# UNITED STATES PATENT AND TRADEMARK OFFICE

APPLICATION NO.	FILING DATE	FIRST NAMED INVENTOR	ATTORNEY DOCKET NO.	CONFIRMATION NO.
10/634,123	08/04/2003	Edmund Koon Tian Lua	2269-5709US (02-1462.00/U)	5763
24247	7590	05/10/2005	EXAMINER	
TRASK BRITT P.O. BOX 2550 SALT LAKE CITY, UT 84110			ANDUJAR, LEONARDO	
			ART UNIT	PAPER NUMBER
			2826

<b>Office Action Summary</b>	<b>Application No.</b> 10/634,123	<b>Applicant(s)</b> LUA ET AL.	
	<b>Examiner</b> Leonardo Andújar	<b>Art Unit</b> 2826

*FIG. 3*

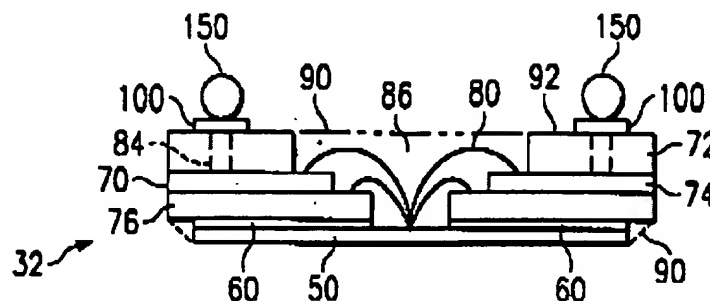
4. Claims 26, 27, 30, 32, 36, 38 and 40 are rejected under 35 U.S.C. 102(b) as being anticipated by Yew et al. (US 6,049,129).
5. Regarding claim 26, Yew (e.g. figs. 2 & 3)) shows a semiconductor assembly comprising: at least one semiconductor die having a plurality of bond pads 120 formed on active surface thereof; at least one anisotropically conductive layer 70 comprising a plurality of laterally isolated conductive elements 84 disposed in a dielectric material 72 (i.e. FR-4) and having an upper end exposed therethrough attached to the active surface by the adhesive layer 60; a plurality of conductive bumps 150 on the at least one anisotropically conductive layer with each of eh plurality of conductive bumps in

contact with at least one conductive element of the plurality; and wire bonds 80 between the bond pads and the conductive bumps.

Fig.3

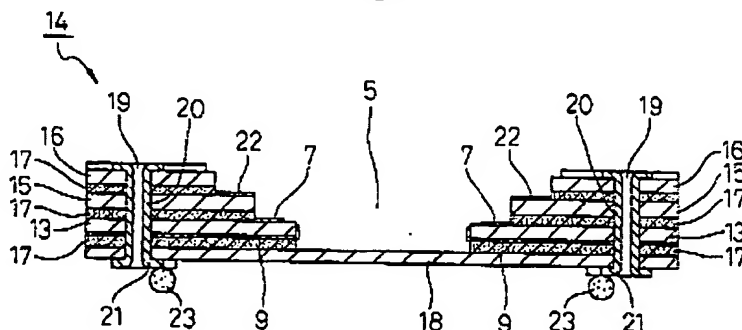
14. Regarding claim 31, Yews shows most aspect of the instant invention except for a conductive element comprising at least one of tungsten, aluminum, copper, silver, gold, and alloys thereof. Nevertheless, Sato (e.g. fig. 3) shows a structure analogous to the conductive layer 72 disclosed by Yews were the conductive element 20 is made of copper.

It would have been obvious to one of ordinary skill in the art at the time the invention was made to make the conductive element disclosed by Yew of copper as

suggested by Sato because copper has a high conductivity, is easily fabricated, and has an excellent corrosion resistance in natural environments.

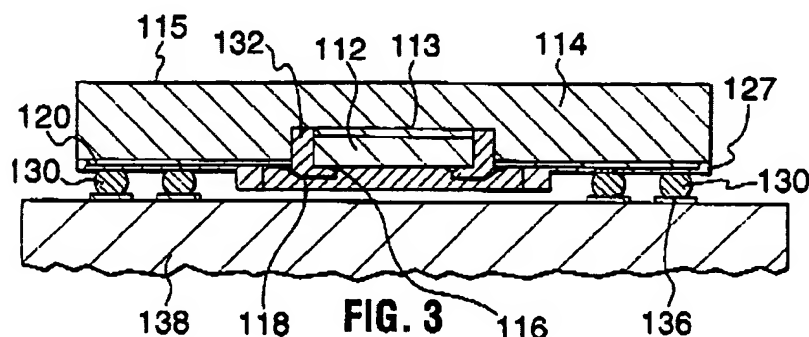
16. Regarding claim 33, Yew teaches most aspects of the instant invention including semiconductor substrate assembly attached to a substrate (col. 2/29-32). Yew does not disclose a substrate having a plurality of terminal pads on a surface thereof; and wire bonds between the plurality of conductive bumps and the plurality of terminal pads. Nevertheless, Marcantonio (e.g. fig. 3) teaches an analogous embodiment that includes a substrate 138 having a plurality of terminal pads 136 on a surface thereof, and wire bonds 118 between the plurality of conductive bumps and the plurality of terminal pads. This type of substrate serves a variety of functions. Foremost, it contains the wiring required to interconnect the components electrically, acts as the primary structure to supports those components and is also used to conduct away heat generated by the components.

surface thereof in Yew's invention as suggested by Marcantonio to provide support, a interconnection medium and a heat transfer path. Note that in this combination the wire bonds are located between the plurality of conductive bumps and the plurality of terminal pads.

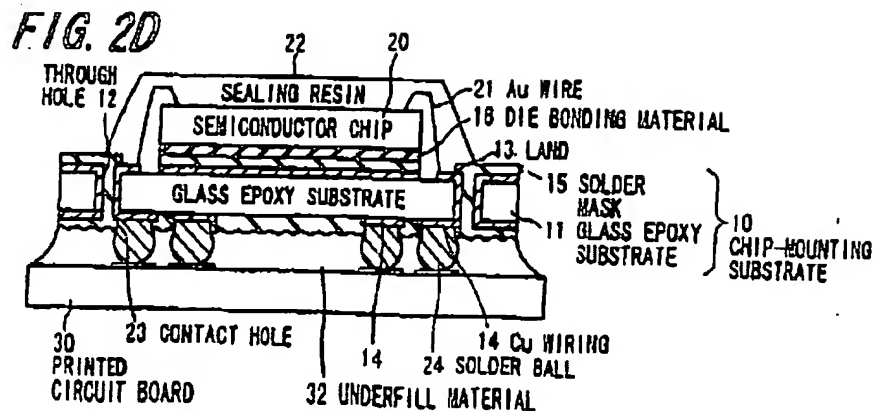
19. Regarding claim 35, Yew teaches most aspects of the instant invention including semiconductor substrate assembly attached to a substrate (col. 2/29-32). Also, Yew shows a dielectric layer 86 over the at least one semiconductor die, the bond pads and the wire pads. Yew does not teach that the dielectric layer is extended to cover the conductive bumps. Nevertheless, Kobayashi (e.g. fig. 2D) teaches a dielectric layer 32 at the outer surface of a dielectric layer 41 and covering conductive bumps 24. According to Kobayashi, this type of embodiment absorbs a stress caused by a difference in the thermal expansion coefficient between the die mounting structure and the substrate and impacts caused by fallings to secure the reliability of soldered jointed portions (col. 1/lis. 34-41).

It would have been obvious to one of ordinary skill in the art at the time the invention was made to cover the outer surface and the conductive bumps disclosed by Yew in order to absorb a stress caused by a difference in the thermal expansion coefficient between the die mounting structure and a substrate and impacts caused by fallings to secure the reliability of soldered jointed portions as suggest by Kobayashi.
